[11] Patent Number: Des. 288,978 [45] Date of Patent: ** Mar. 24, 1987

[54]	PALLET		4,413,737 11/1983 Wind 108/53.1
[75]	Inventor:	Joseph H. Wind, Taylors, S.C.	Primary Examiner—James M. Gandy Assistant Examiner—Kay H. Chin Attorney, Agent, or Firm—Bell, Seltzer, Park & Gibson
[73]	<u> </u>	Bigelow-Sanford, Inc., Greenville, S.C.	
			[57] CLAIM
[**]	Term:	14 Years	The ornamental design for a pallet, substantially as shown and described. DESCRIPTION
[21]	Appl. No.:	655,549	
[22] [52]	Filed:	Sep. 28, 1984 D34/38	FIG. 1 is a top perspective view of the pallet showing my new design;
[58]	 Field of Search D34/38; 108/51.1, 52.1, 108/53.3, 55.3 References Cited U.S. PATENT DOCUMENTS 		FIG. 2 is a front elevation thereof looking in the direction of arrow 2 in FIG. 1; FIG. 3 is a bottom perspective view thereof; FIG. 4 is a side elevational view thereof looking in the direction of arrow 4 in FIG. 1; FIG. 5 is a top plan view thereof; and FIG. 6 is a bottom plan view thereof.

UNITED STATES PATENT AND TRADEMARK OFFICE CERTIFICATE OF CORRECTION

U.S. Patent Mar. 24, 1987 Sheet 3 of 3 Des. 288,978

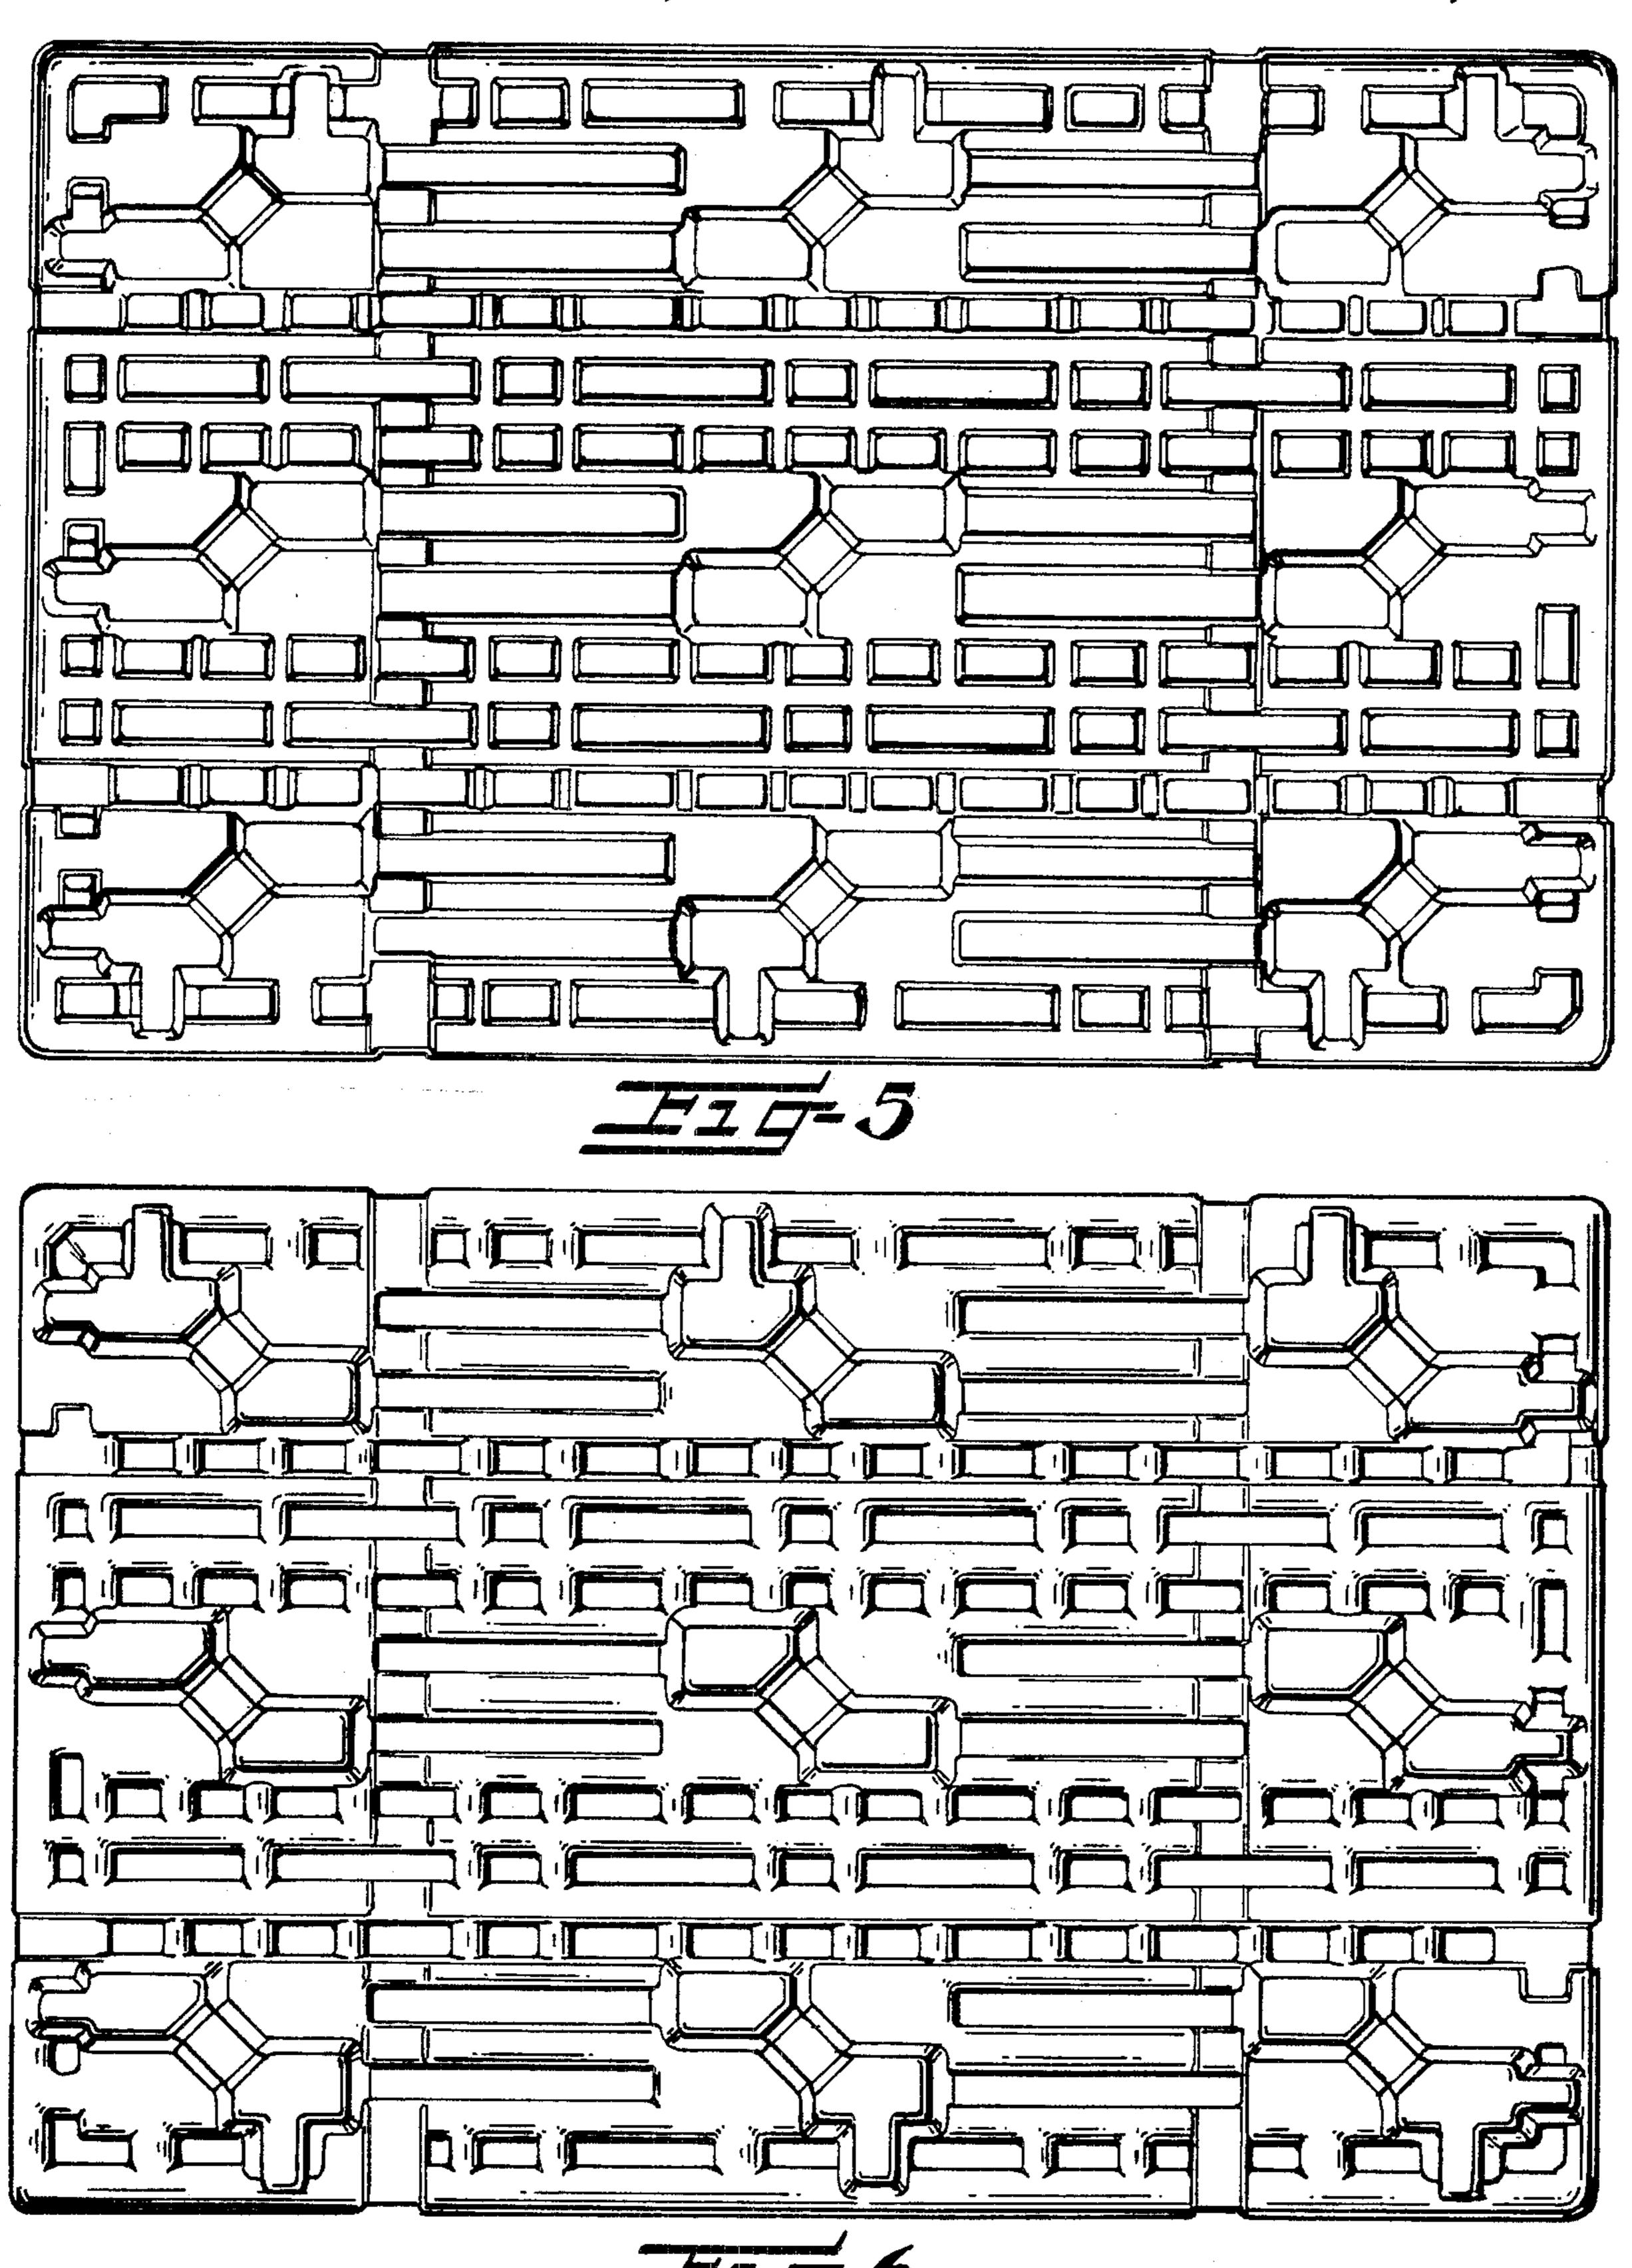
Sheet 3 of 3 of the Drawings consisting of Figures 5 and 6 should be deleted to appear as per attached sheet.
